Project	IEEE 802.16 Broadband Wireless Access Working Group < http://ieee802.org/16 >	
Title	Unique Randomizer Initialization for Interference Management in 802.16 OFDM PHY	
Date Submitted	2004-03-13	
Source(s)	Adam Kerr, Paul Petrus ArrayComm, 2480 North First St. San Jose, CA 95131-1014	Voice: 408-428-9080 Fax: 408-428-9083 E-mail:adam@, petrus@arraycomm.com
Re:	IEEE 802.16-REVd/D3-2004	
Abstract	Describes changes to initialization vector for randomizer in OFDM-256 PHY.	
Purpose	These changes will provide for improved detection of error at the PHY level in low reuse networks.	
Notice	This document has been prepared to assist IEEE 802.16. It is offered as a basis for discussion and is not binding on the contributing individual(s) or organization(s). The material in this document is SSbject to change in form and content after further study. The contributor(s) reserve(s) the right to add, amend or withdraw material contained herein.

Unique Randomizer Initialization for Interference Management in 802.16d OFDM PHY

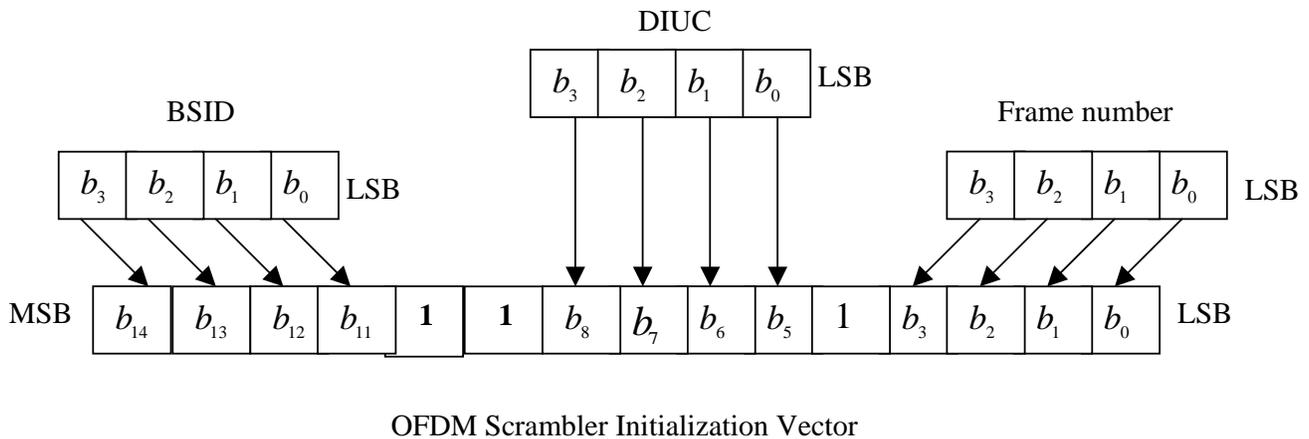
The current randomization (scrambling) process for the 802.16 OFDM PHY is performed by a modulo-2 addition to each uplink or downlink data burst with a pseudo-random binary sequence output from a linear feedback shift register as described in 8.3.3.1 of [2].

The shift register is 15 bits long, with a seed value that is initialized at the beginning of each frame on the downlink, and again at the beginning of each downlink burst (not including burst #1). On uplink, the randomizer seed is initialized at the beginning of each burst. Preambles are not scrambled.

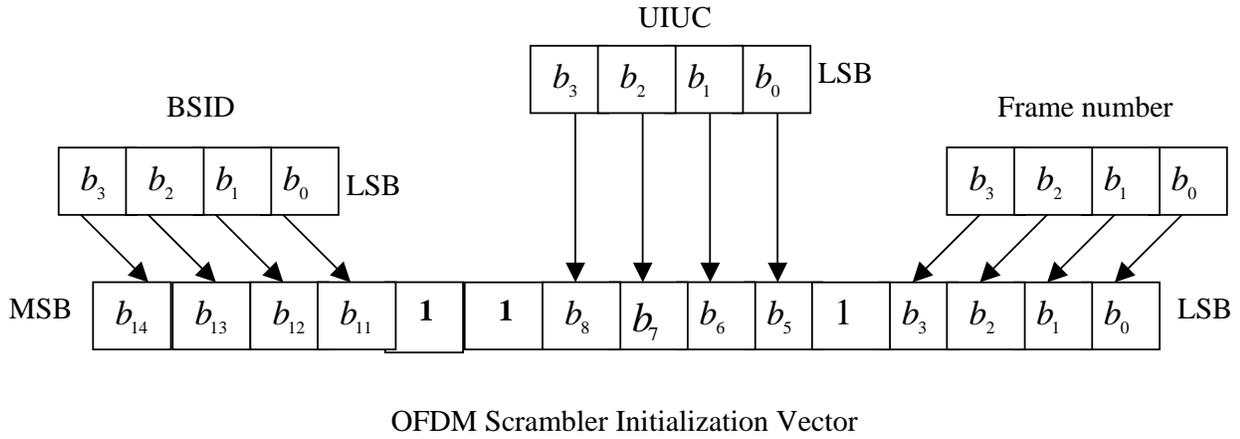
- 1) The paragraph immediately above Figure 192 is changed to read:
 “On the downlink, the randomizer shall be re-initialized at the start of each frame with the vector: 1 0 0 1 0 1 0 1 0 0 0 0 0 0. The randomizer shall not be reset at the start of burst #1. At the start of subsequent bursts, the vector shown in Figure 192 shall be used to initialize the randomizer.”
- 2) The paragraph immediately above Figure 193 is changed to read:
 “On the uplink, the randomizer is initialized with the vector shown in Figure 193.”
- 3) Figure 192 is replaced with:

In order to create a randomization that is dependent on both base station and the connection, we introduce modifications to this seed value. For the preambles and broadcast portion of the downlink frame (FCH and burst #1) we recommend maintaining the fixed constant seed value as currently defined. For all other downlink bursts and all uplink bursts, we recommend that a combination of base station ID, DIUC/UIUC and frame number form the seed value for the shift register, rather than the current combination of DIUC/UIUC and symbol number.

The base station ID is a 48-bit value with the upper 24 bits being the operator ID, and the lower 24 bits used to identify the base station, while the frame number is 24 bits long. We recommend that the new randomizer seed values be formed from the lowest 4 bits of the base station ID, 4 bits of DIUC/UIUC and the lowest 4 bits of frame number.
